SERVICE BULLETIN

M-1135

Ignition Switch Cover Concerns

Figure 1. Ignition Switch

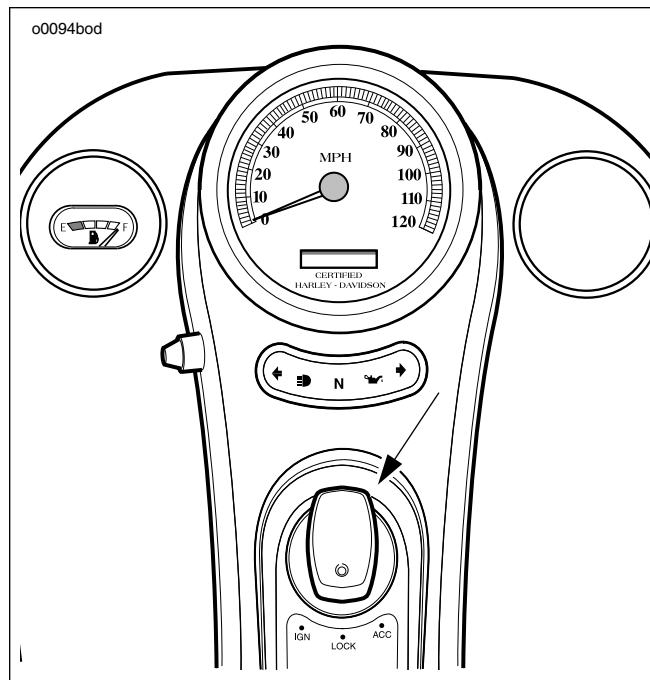
Harley-Davidson has learned that there may be an issue with the ignition switch cover not staying in the closed position on certain vehicles featuring a fuel tank console mounted ignition switch. A revised switch is now available by ordering part number 71313-96A.

If a customer identifies this issue with their vehicle, replace the switch with the revised switch assembly.

1. Remove and replace ignition switch. See service manual.
